MEMORANDUM

To: The Design Advisory Board
From: Mary O'Neil, AICP, Principal Planner
RE: ZP20-0667CA; 188 South Champlain Street
Date: ~~March 24, 2020~~ ~~April 14, 2020~~ ~~April 28, 2020~~ May 26, 2020

Request: Convert single family to six units. Expanded parking. Request for a 6 space parking waiver.

PROPOSED
CONDITIONS
PLAN

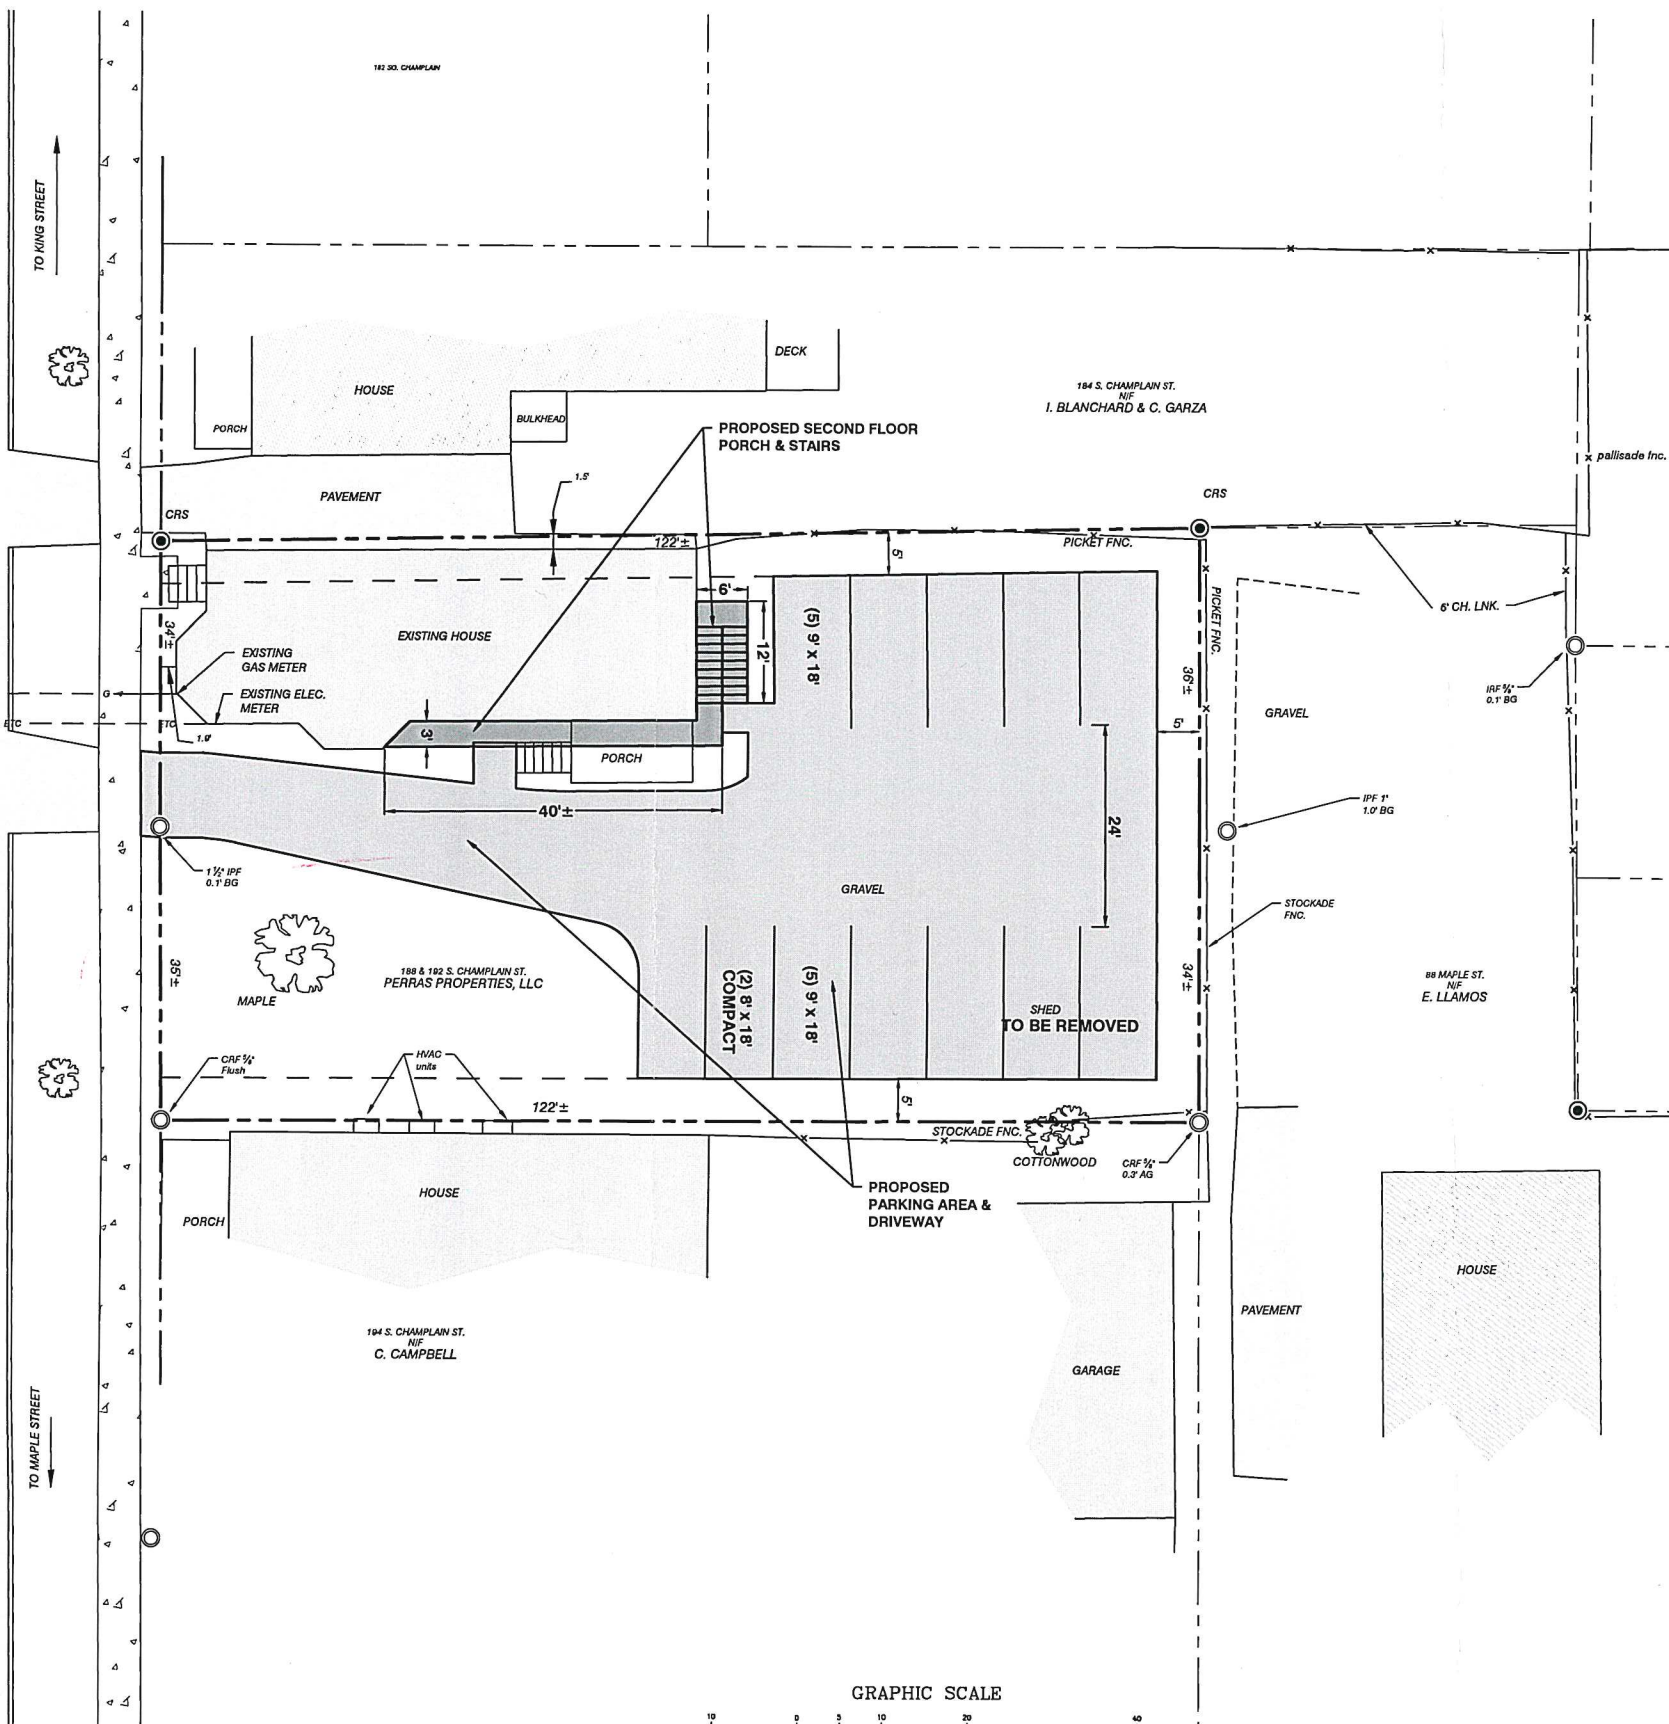
There is no identified snow removal or storage identified on the site plan.

No change is proposed from the current building access from the public sidewalks. There is, however, no well-defined pedestrian route through the parking areas to the primary building access points. This should be designed to provide a physical separation between vehicles and pedestrians in a manner that minimizes conflicts and improves safety.

In the Neighborhood Parking District, 2 parking spaces are required for every residential unit. 6 units will require 12 on-site parking spaces, which are illustrated on the plan. All parking spaces are dimensioned for compact cars (18' length.) The required 24' of backup space is provided. The minimum required 5' parking setback is provided from the north, south and east property lines.

While the parking is arranged on the side of the lot, screening is required between it and the street, and neighboring property to minimize the visual impacts.

The parking area is identified as gravel. To avoid “parking creep” and vehicular pull of gravel out into the street, the parking lot should be paved and parking spaces clearly marked. The perimeter of the parking area must be designed with curb stops, landscaping, or other such physical barrier to prevent vehicles from encroaching into adjacent green spaces and into required setbacks.

This standard also requires shading of 30% of the parking area. The applicant shall define the new tree species, caliper and their location, unless existing trees can provide the required shading.

The applicant has not defined the number and location of bicycle parking spaces.

No landscaping plan has been provided. Screening will be required for the parking area. See 6.2.2 (l), above.

The submission include a fixture spec sheet for a wall mounted residential fixture. The location of these installations is not identified on the plans and should be.

The location of mailboxes is not identified on the plans. If there is any mechanical equipment proposed, it, too should be illustrated on the site plan and building elevations as appropriate.

Since the shed is proposed for removal, the location of trash and recycling needs to be identified; designed to be screened from public view and enclosed on all four sides.

- Parking areas must be screened from adjacent properties and the public right-of-way. A landscaping plan shall be provided to accomplish this.
- If the parking waiver is granted by the DRB, a revised site plan and coverage calculation shall be submitted to reflect the smaller parking area.

- If the parking area is expanded to 12 spaces, the applicant shall demonstrate or cause shading of at least 30% of the parking area. This plan shall be provided to staff for review.

- The location of light fixtures shall be identified on the plan.
- The location of trash and recycling shall be located on the plan. Trash should be enclosed on all four sides to prevent the refuse from blowing.

- The location of mailboxes shall be identified on the plan and subject to review and approval. Gang-style mailboxes on the sidewalk are not favored.
- The applicant shall define the location of bicycle parking. For six units, at least **3 long term spaces** (one for every two bedrooms) and **1 short term space** (1/10 units) shall be provided.

Perras Renovation
188 South Champlain St
Proposed First Floor
2/12/20

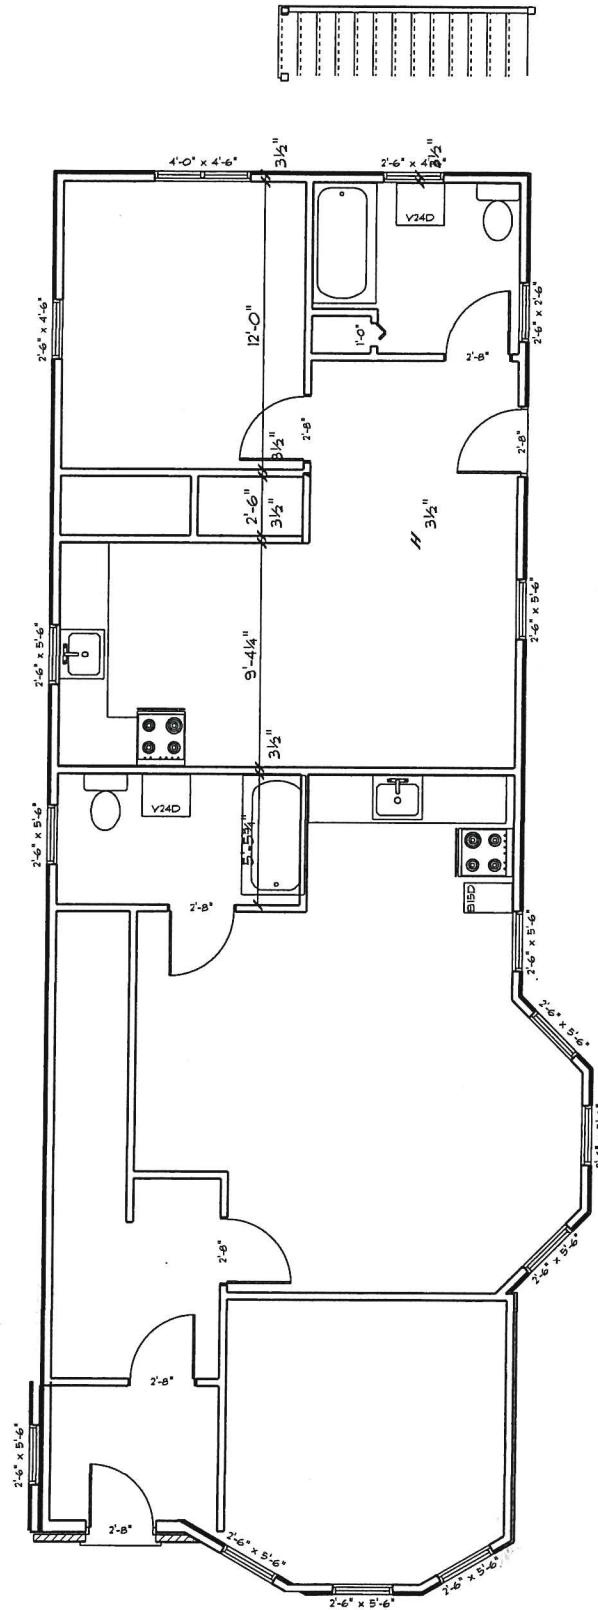
- The first floor proposed floorplan shall be corrected to illustrate the location of a doorway into the front parlor.
- Functional Family provisions of the ordinance shall apply. Not more than four unrelated adults may occupy any unit.

400 Series
Tilt-Wash Double-Hung
Full-Frame Windows

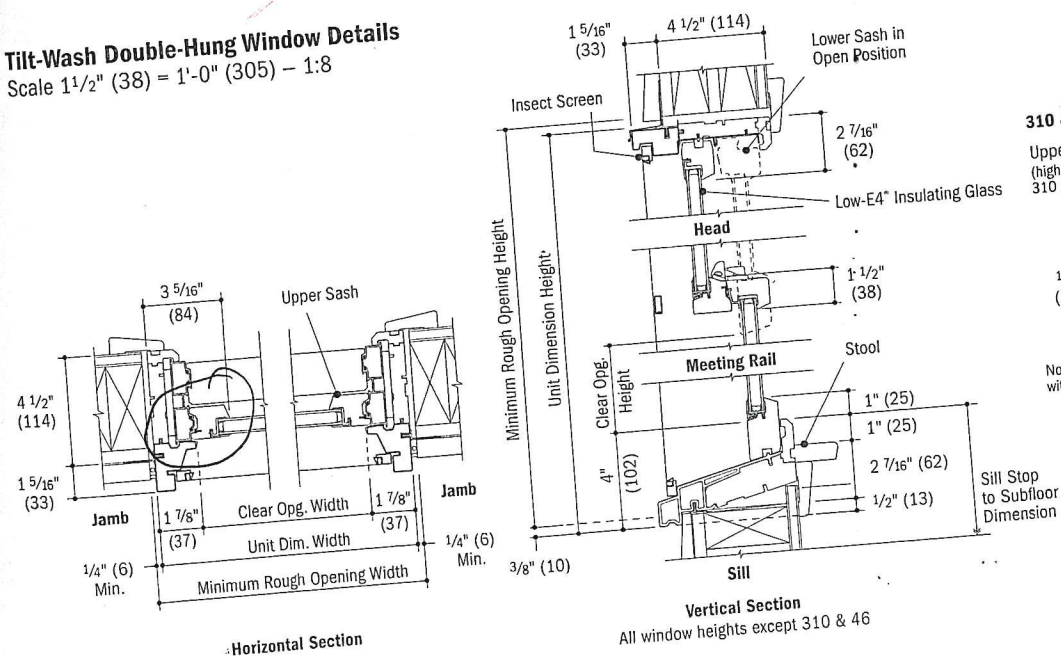
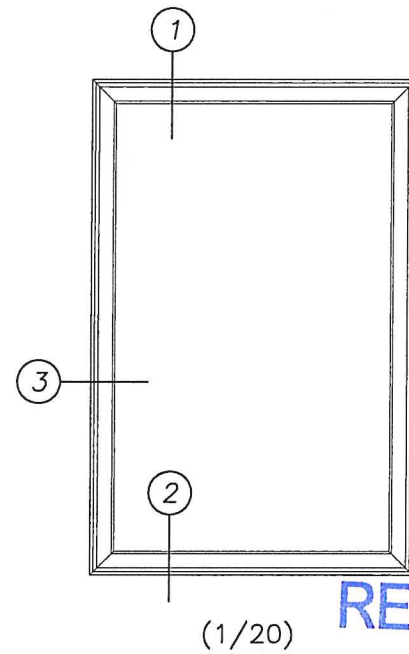
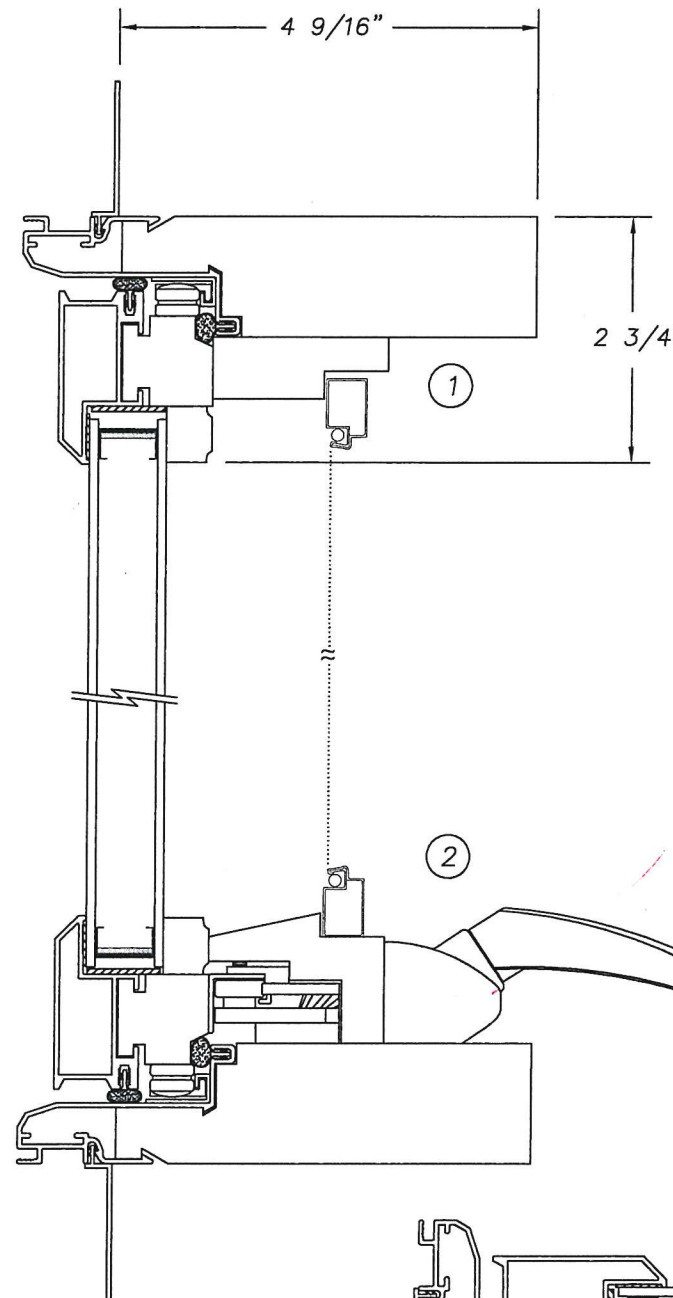
All windows are proposed for replacement; some are double hung and others casement. Although one specification sheet defines “Wood casement”, the cross section illustrates voids in the window frame, sill and apron, suggesting a composite structural material. Confirmation of **solid wood core windows**, and casement windows with a strong meeting rail to visually replicate a double hung window, will be required.

RAMPING 42" TALL
BALUSTERS 5 1/2" ON CENTER
5 1/2" COMPOSITE DECKING
PRESSURE TREATED STRUCTURE
4x4 POSTS MAX 6' ON CENTER

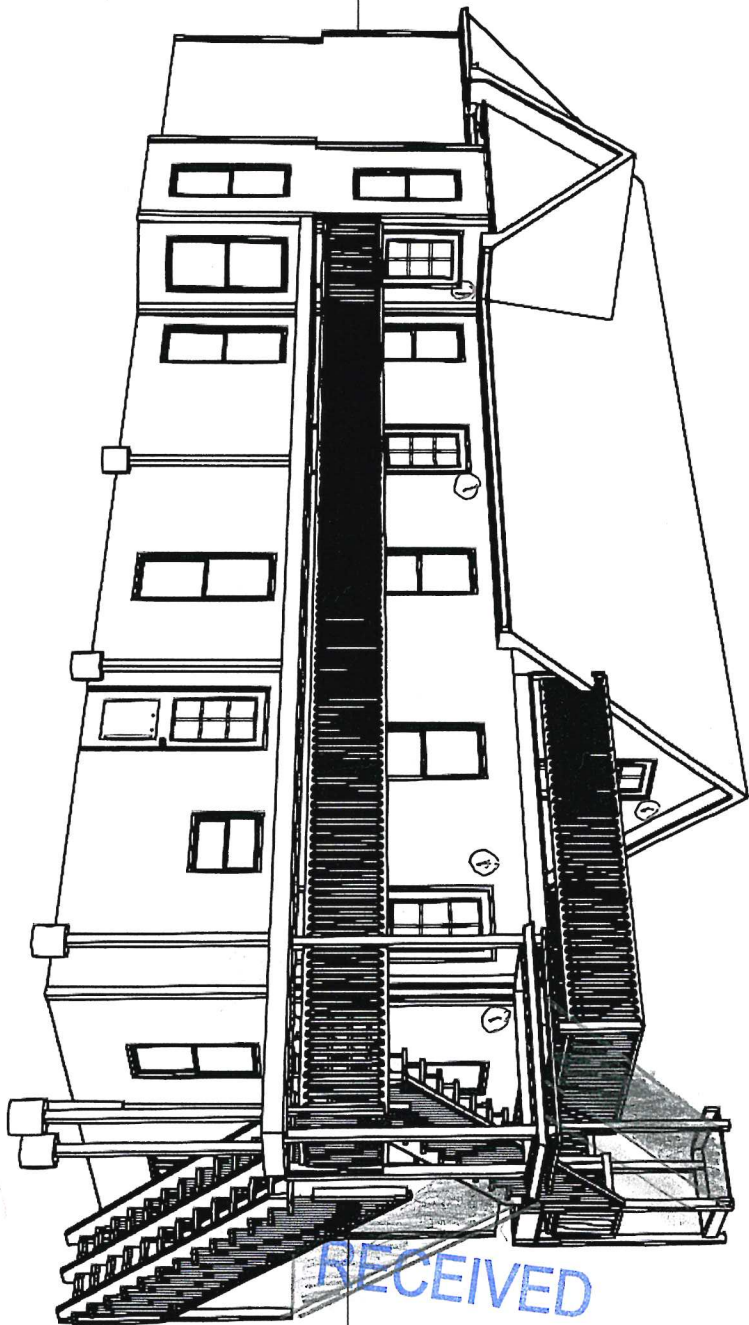
The existing building will remain, with a newly design access deck on the east and south.

The existing building will remain. The proposed deck will have no roof.

225 Elmwood Ave.

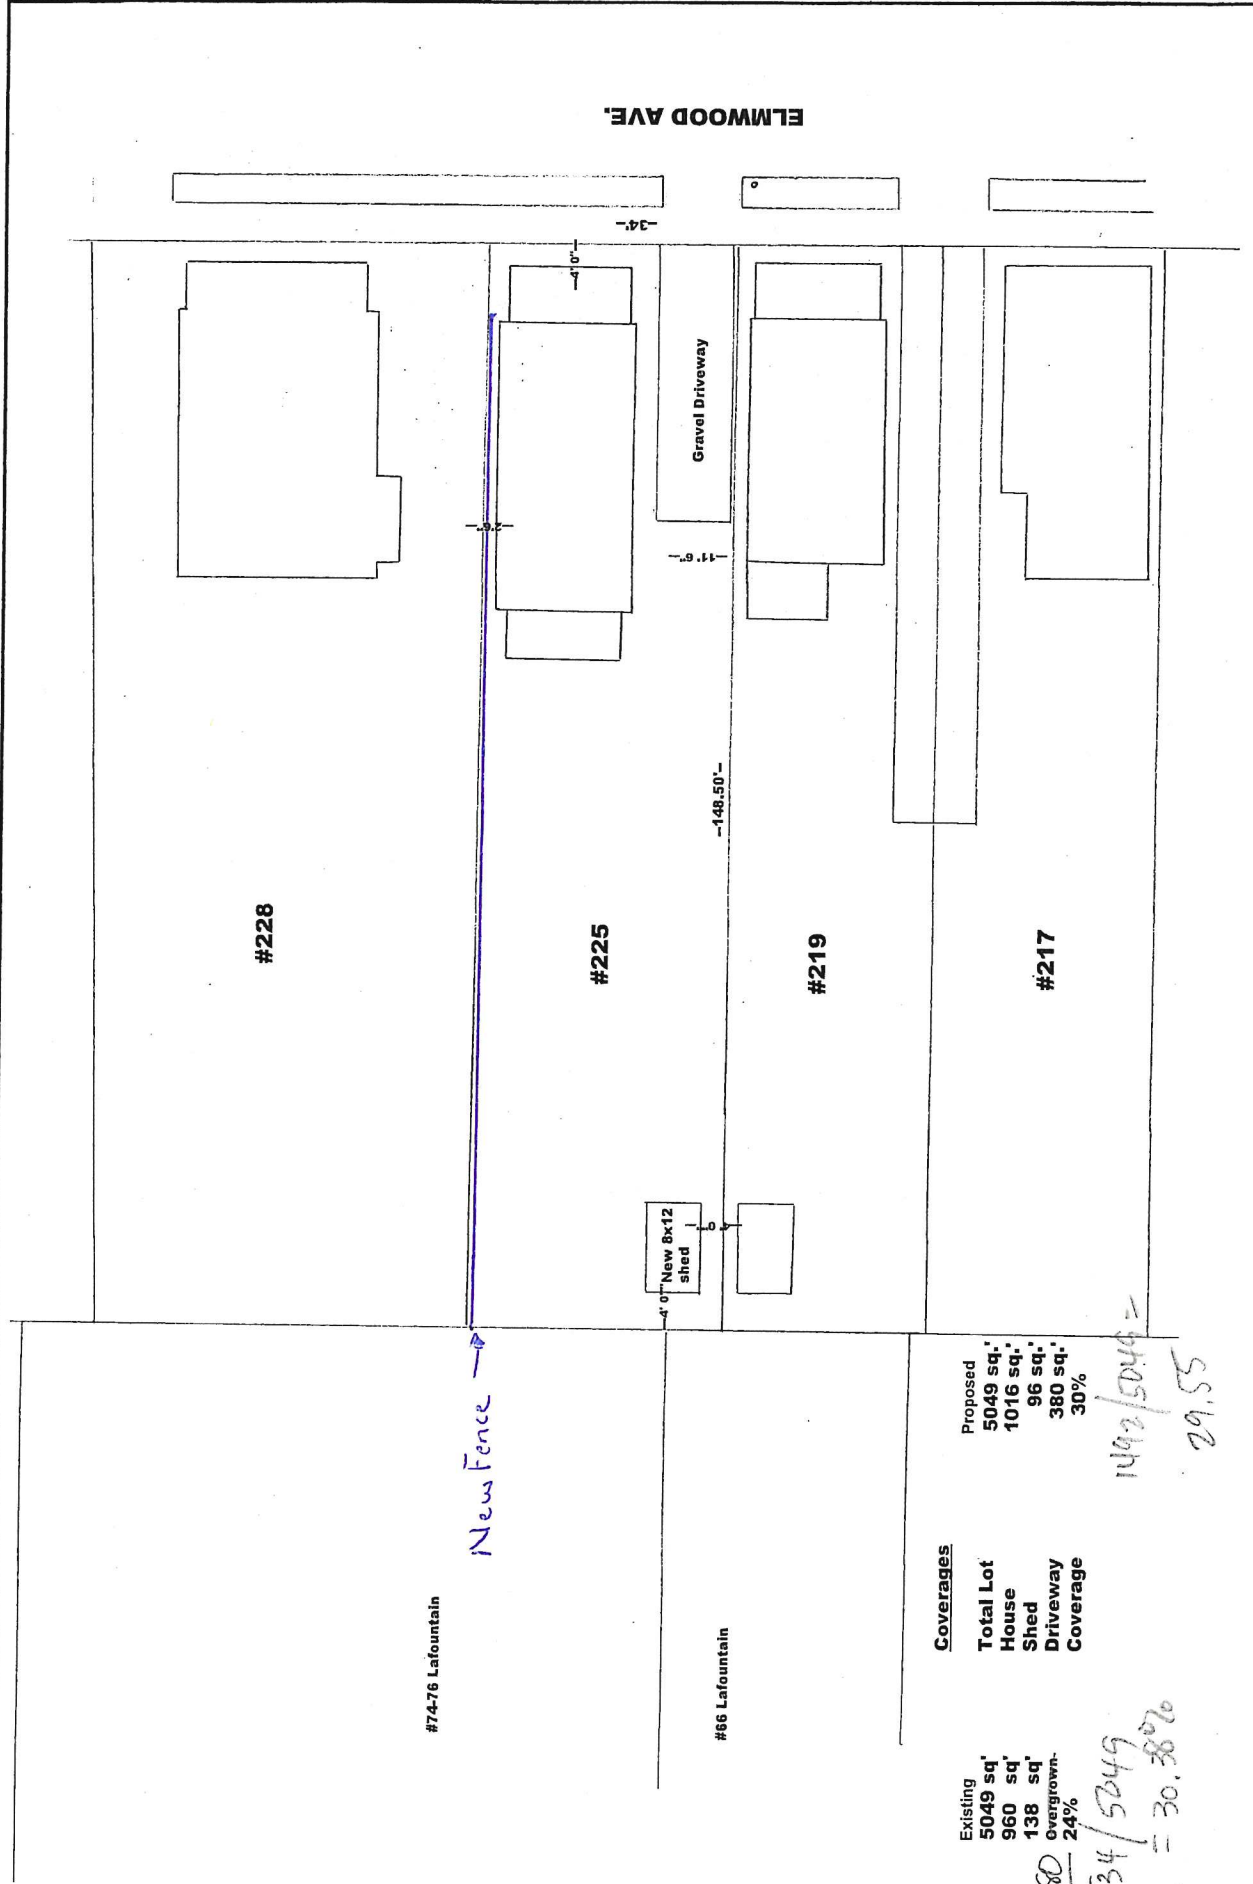
There is a public sidewalk along the west side of Elmwood Avenue. The site plan does not illustrate a walkway connecting the sidewalk to the new residence, which is required.

The open porch, with a visible front entry and a porch light will provide a welcoming introduction to the street. A walkway will be required from the front entry to the public sidewalk.
